Tice River Homes Legacy

model
40-03

project #
17052

GROUND FLOOR ELEV 'A'

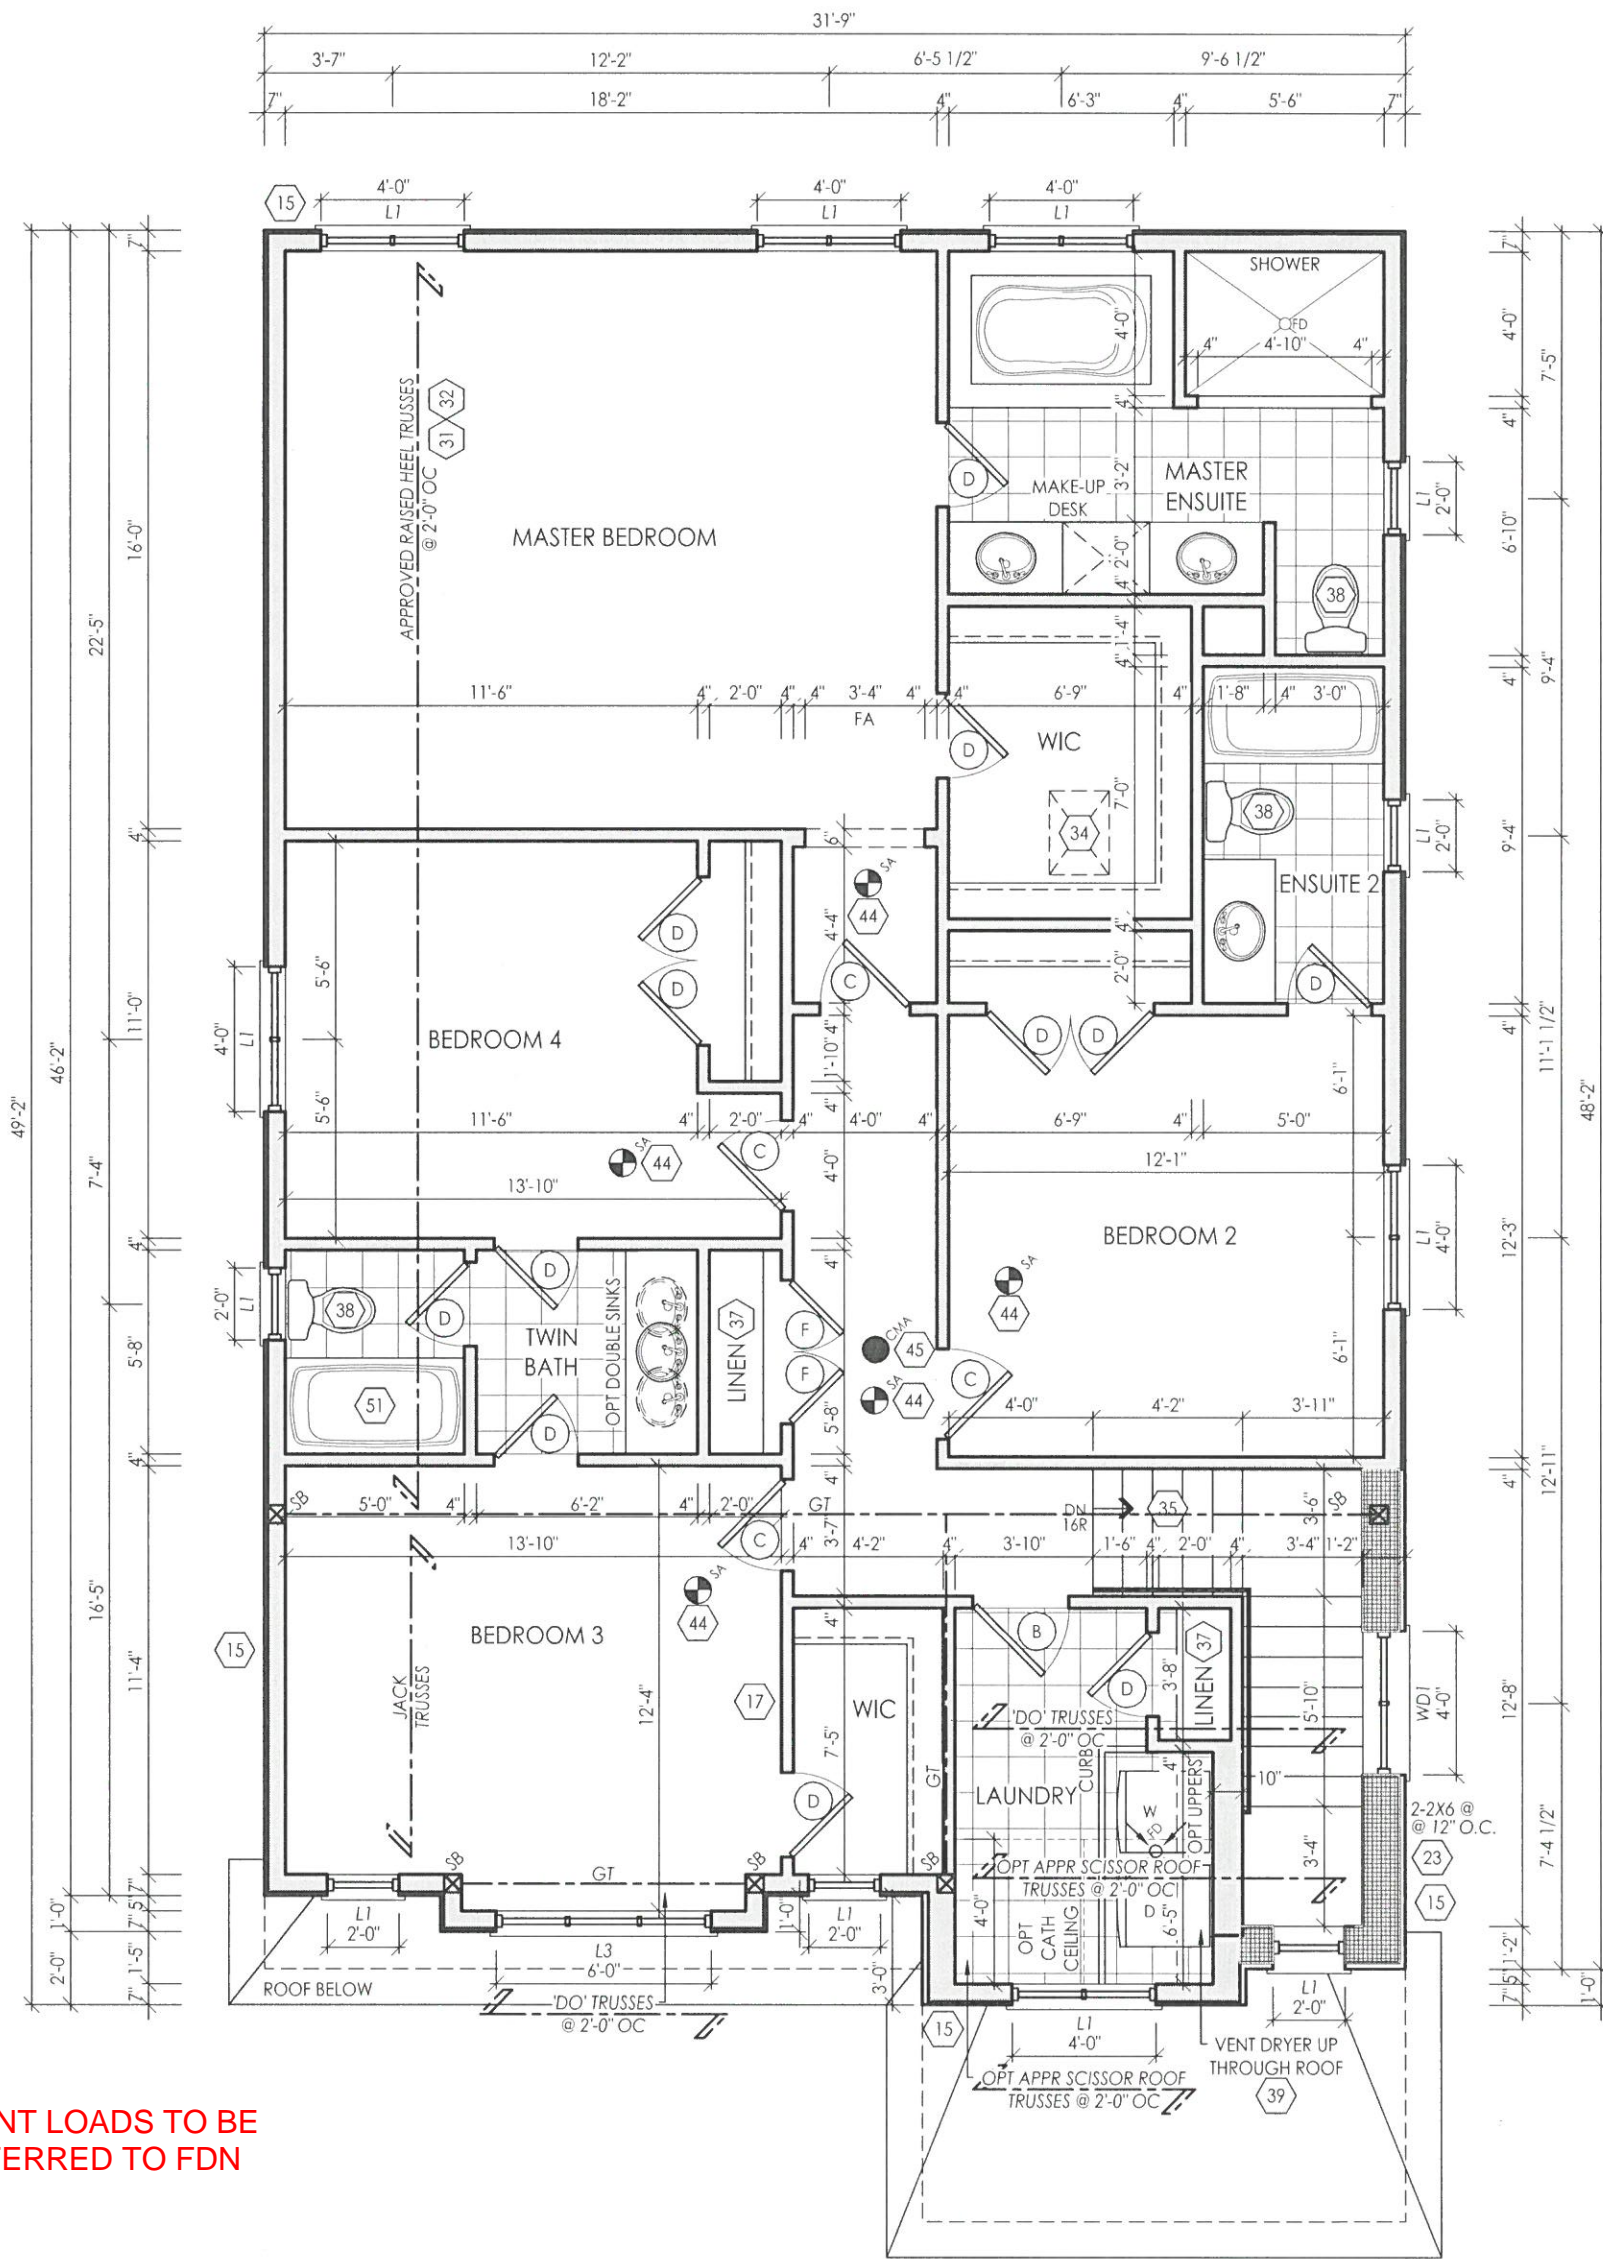
BEAM AND LINTEL SIZES TO BE NOTED ON FUTURE PLANS

LINTEL PACKAGE AND ENGINEERED BEAM DETAILS TO BE SUBMITTED PRIOR TO FRAMING INSPECTION

BEAM/FLOOR CONNECTION DETAILS REQD AT FRAMING INSPECTION

GARAGE WALL AND CEILING TO BE GAS PROOFED

GARAGE MAN DOOR TO BE SELF CLOSING, LATCHING AND WEATHER STRIPPED
